**AGENDA FOR REGULAR MEETING
VILLAGE OF TINLEY PARK
PLAN COMMISSION**

PLAN COMMISSION STAFF REPORT

Bank of America

Site Plan Approval,
Minor Deviation with an
exception

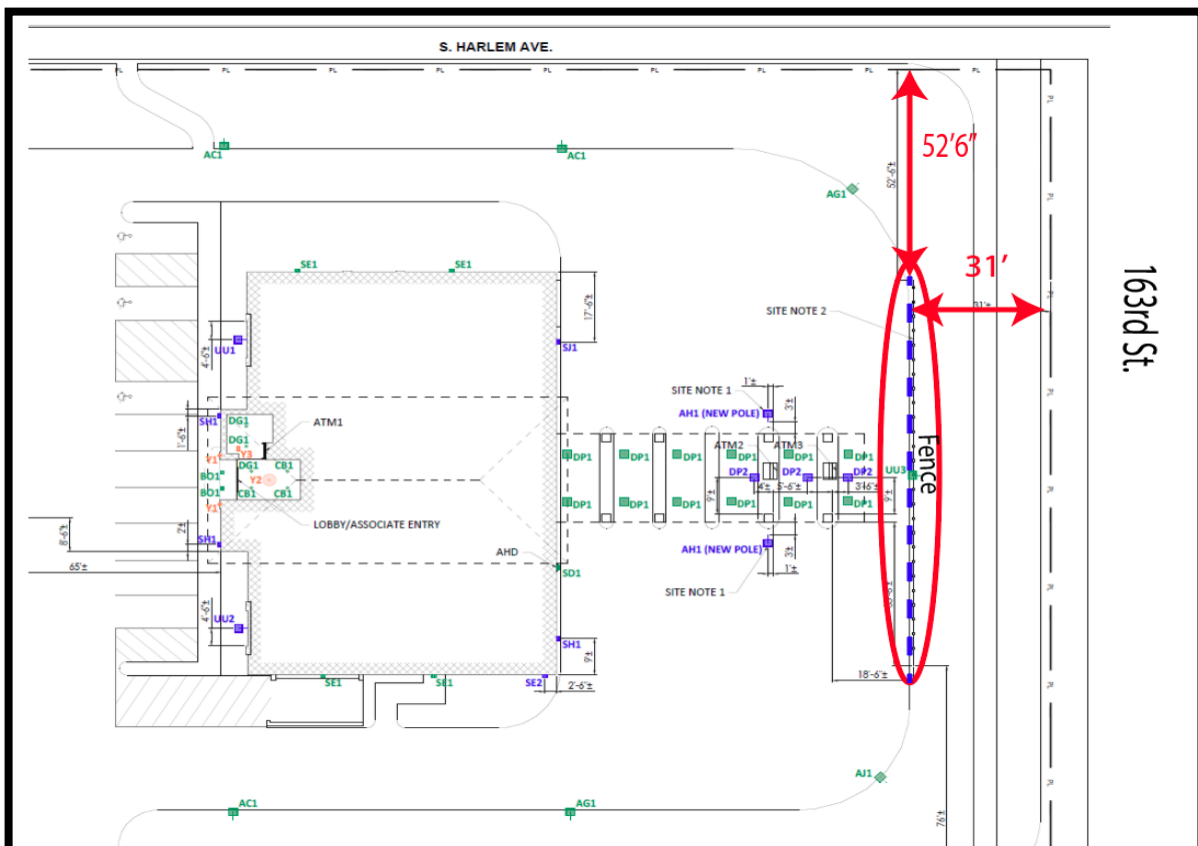
The subject property (highlighted in yellow) is zoned B-4 PUD (Office and Service Business District, Maple Grove Center PUD, amended Brementowne PUD). The nearby zoning includes R-6 to the east, B-4 to the north and south and B-3 to the west.

The Applicant is proposing to construct a 6' fence in the front yard approximately 31' from their north property line. Fences are not allowed in the front yard (or secondary front yard) in Commercial Districts; they must meet the 50' front yard setback. In the context of a Planned Unit Development, any variance from code is considered an

Open Item #1: The Plan Commission may consider a Minor Deviation to allow a 6' fence in the front yard of a commercially zoned property in the Maple Grove Center PUD.

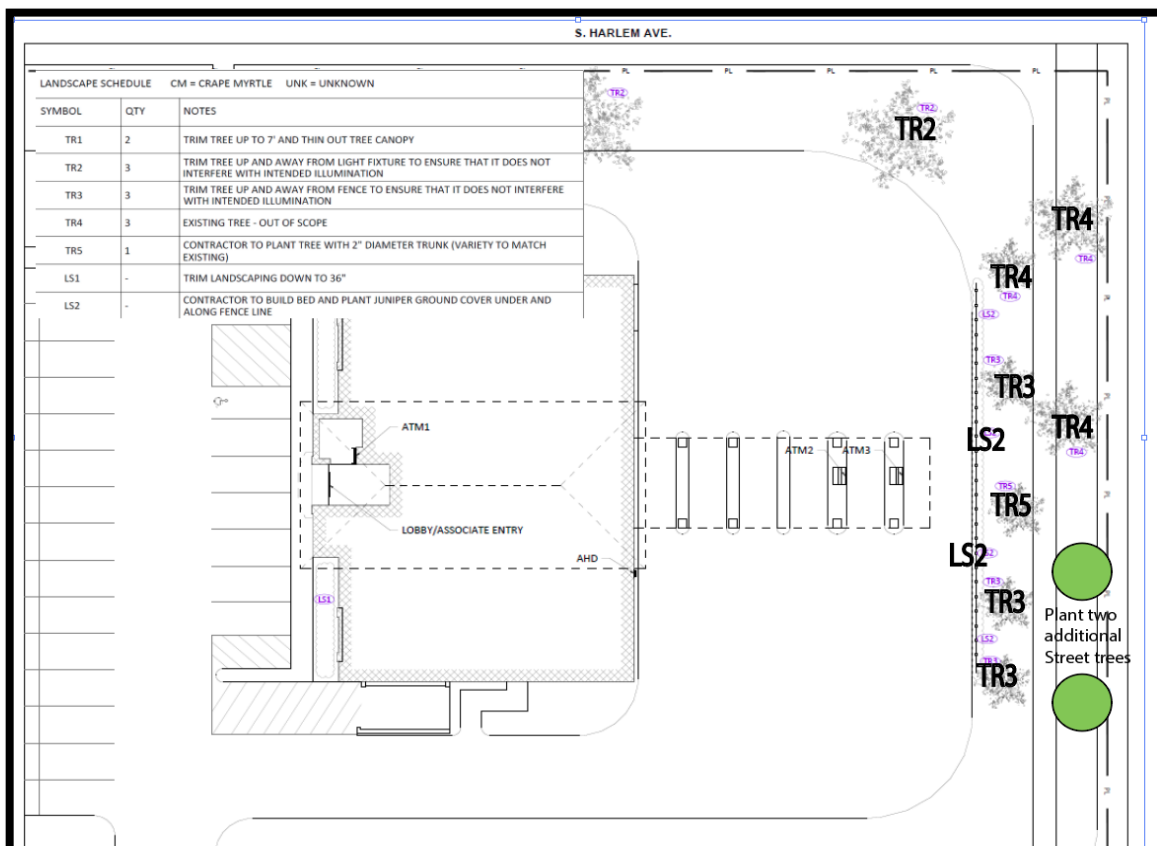
The Petitioner seeks Site Plan Approval for the construction of a 6' fence to be located along the north curb line of the drive up area. There is also some minor landscaping that will be installed in this area. The fence will be located 31' from the north property line and 52'6" from its west property line. The Compliance Consultant has stated that the fence must be 6' in height to meet the intent of the statutes.

The Applicant has selected a 6', open style black aluminum fence (Echelon Majestic, by Ameristar). Although the code does not allow fences in the front yard, fences are allowed to be 6' in Commercial Districts. If the Commission supports the exception for a fence of this height in the front yard Staff recommends it be conditioned upon specifying this type of fence.

Open Item #2: Condition approval on erecting a 6" Echelon Majestic, by Ameristar black aluminum fence.

LANDSCAPING PLAN

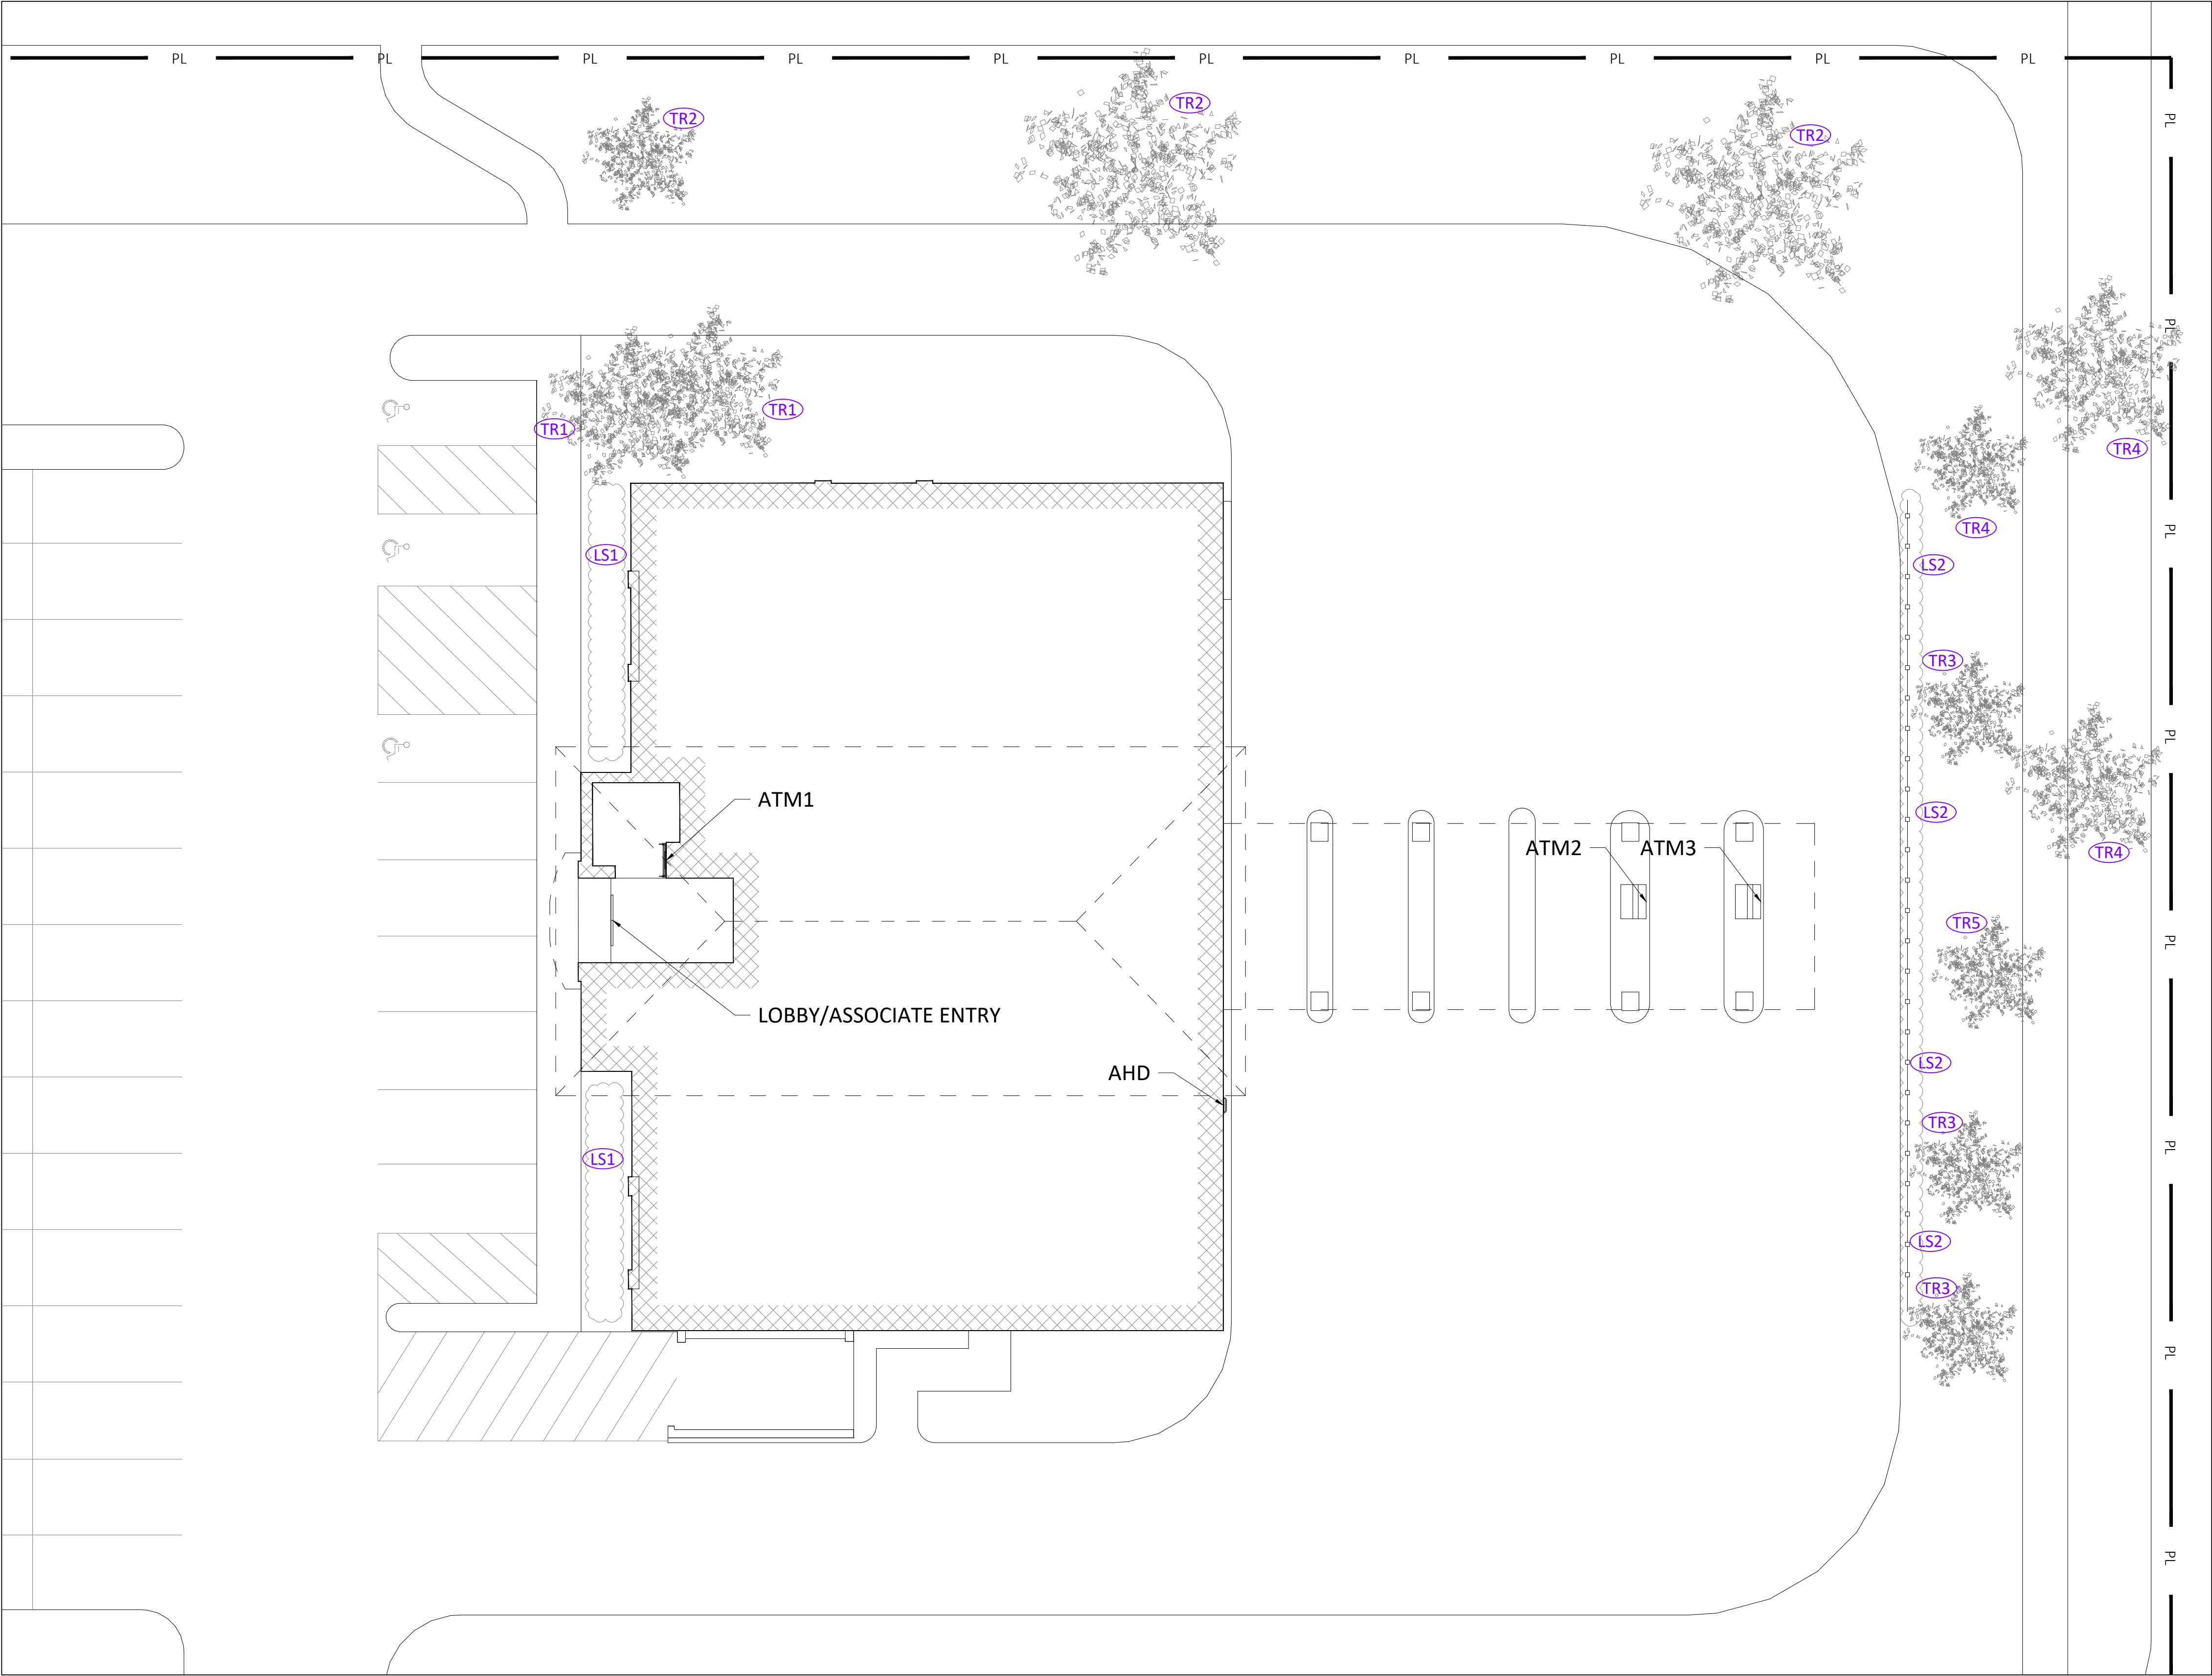
As part of the security upgrades the Bank will be trimming up some of the existing vegetation around the ATM area to allow for better views on and off the site. TR2 and TR3 are existing trees that will be trimmed. TR5 is a new tree to match the existing trees in size and cultivar. The existing planting beds will remain and additional low growing evergreens will be planted under and along the fence line (LS2).

Street trees are required to be planted every 25' along public right-of-ways; two (2) additional trees will need to be planted to meet code requirements. Due to the visibility concerns staff considers the remaining existing landscape to meet the integrity of the Landscape Ordinance bufferyard requirements.

Open Item #3: Plant two additional street trees along 163rd Street, 25' apart.

- erect a 6" Echelon Majestic, by Ameristar black aluminum fence.
- Installation of two (2) additional street trees along 163rd Street.
